## NOTICE OF EXEMPTION

**PROJECT TITLE:** Re-Roof Castro Adobe Structure

**LOCATION:** Rancho San Andres Castro Adobe      **COUNTY:** Santa Cruz

California Department of Parks and Recreation  
Historical Review ☒ Archaeological Review ☐ Both ☐  
Project Evaluation  
(P.R.C. 5024, 5024.5 and E.O. W-26-92)

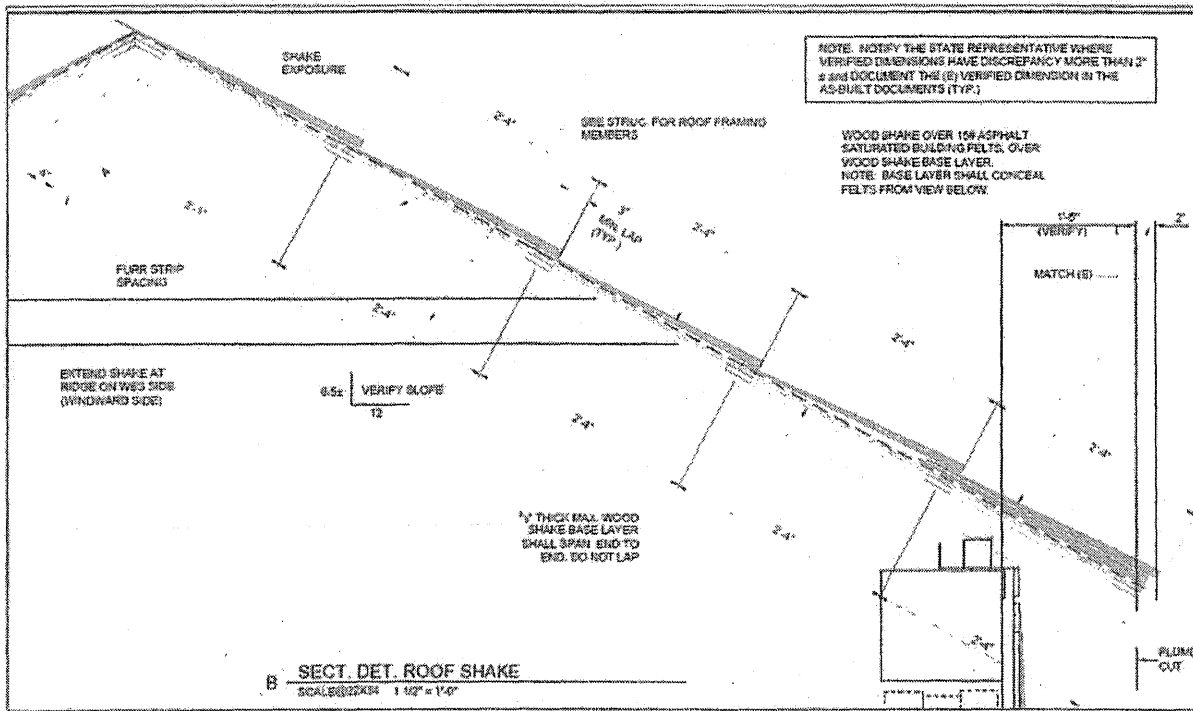
**Explain:** If the ceiling is not reinstalled on the second floor, the exposed rafters must show the shingles from underneath. To avoid an **Adverse Effect** on the building **Cultural Condition 1** must be followed.

**Cultural Condition 1:** If the rafters are still exposed, install a layer of shingles directly to the rafters before adding 15# asphalt saturated building felt or similar product over this base layer of shingles before installing the exposed roofing shingles on top of felt (See drawing below). Note: this method is only for the exposed areas of the *Corredor* roof. (While roofing felt is preferred, ice and water shield is acceptable.) The 2010 HSR describes a similar method that was used on the *Cocina*:

"The HSR recommended that the *cocina* be roofed with 36" long barn shingles as shown in the earliest photographs we have. Originally, the shingles would have been installed directly on top of skip sheathing as the finished roof. Now, standing inside the *cocina* and looking up at the under side of the new roof, one sees a layer of shingles above the skip sheathing to give the correct appearance in the interior (Photograph 12) [in the HSR]. Above this, the engineered roof has layers of plywood, underlayment, breathable membrane, and the exterior layer of 36" long shingles" (page 10-11).

**Cultural Condition 1:** If the rafters are still exposed, install a layer of shingles directly to the rafters before adding 15# asphalt saturated building felt or similar product over this base layer of shingles before installing the exposed roofing shingles on top of felt (See drawing below). Note: this method is only for the exposed areas of the *Corredor* roof. (While roofing felt is preferred, ice and water shield is acceptable.)

Fig. 1

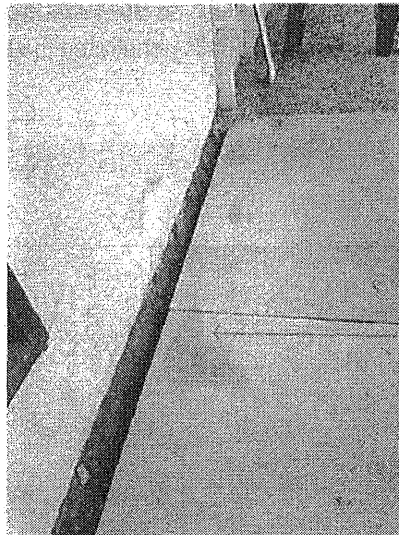
During the winter of 2016-2017, this office visited the Castro Adobe in Watsonville on several occasions to observe the work that we designed for the Phase 3 work. During one of our site visits, it was discovered that rainwater was leaking through the east roof overhanging the *Corredor* and falling on the ground surface below (Fig. 1).

**Evaluation:** The report recommends installation of boards underneath the rafters to form a ceiling in the *Corredor* and then installing some kind of membrane underlying the shingles. This recommendation contradicts the recommendations of the HSR (See page 90) that states, "The solid sheathing of the *Corredor* roof is termite ridden and should be replaced with skip sheathing with the shingles visible on the underside as is historically accurate." This requirement was continued in the updated HSR from 2010 (Hildebrand and Wulzen 2010) which states, "A layer of plywood rests directly on the rafters; it extends to the exterior face of the walls. Layers of underlayment and breathable membrane are sandwiched beneath the shingles of the finished roof. Over the *corredor*, skip sheathing has been used instead of plywood to achieve the appearance of the simple original roof from the under side. This detail should not be painted" (page 18). In most cases, any variation from this design is an Adverse Effect on the building. In this case, however, The HSR identifies that the ceiling upstairs should be restored. There is a potential project to complete this task. If the ceiling is restored, this action will have No Adverse Effect to the building. If the ceiling is not restored, then there will be an Adverse Effect. To reduce this effect to having No Adverse Effect on the building, see Condition 1 in Section V.A.

Fig. 4

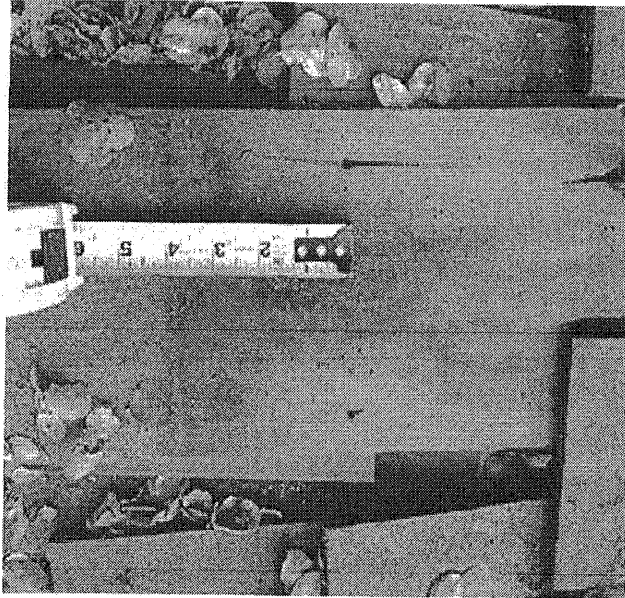
Secondarily, the nailing location was not at a recommended\* location: the nails were placed too high up on the shingle- normal practice is to nail approx. 1.5" above the exposure line and the sample shingle we examined was 4" above the line. (Fig. 4)

**Evaluation:** The stainless steel nails were approved in the original project and were part of the specifications. They should have been used. The previous project also deviated from standard nailing locations. The proposed project will use the appropriate nails and locations. The exposure was wrong because the previous project failed to use the shingles specified in the HSR. The 18" shingles specified would have had the appropriate area of shingle exposed. All three of these actions are correcting issues based on the previous project not following the project specifications. Those specifications, including the shingled roof were approved in the HSR and supplemental HSR. This proposed work will have **No Adverse Effect** on the building.

Fig. 5

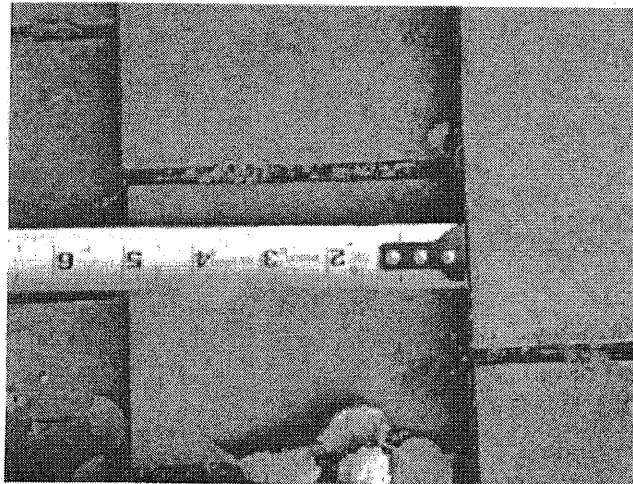
Thirdly, the exposure (part of shingle left to the weather) for the shingles was too great. At 5" (Fig. 5), the exposure creates a situation that invites curling and cupping. Recommended\* exposure for a #1 shingle that is 16" long is 3 3/4" max.
